# Service Bulletin

Bulletin No.: 22-NA-165

**Subject: Brake Squeal Noise at Low Speeds (Pursuit Rated Option)**

6581016

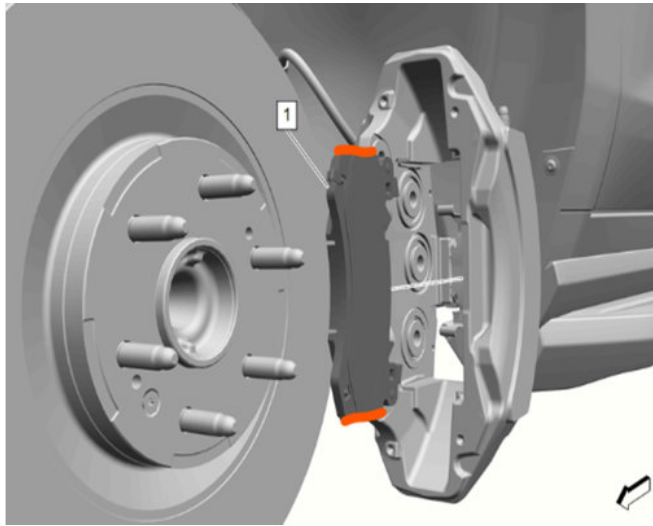
- Apply approximately 0.09-0.15 g (0.003-0.005 oz) of copper past PN# 19303310 (PN# 19303311 Canada) or equivalent on the brake pad abutments (1), as shown in the picture above, which contacts the brake caliper.

**Important: DO NOT** get any copper paste (grease) on the friction face, **OR** any of the rubber components of the caliper, **OR** on the back of the brake pad.
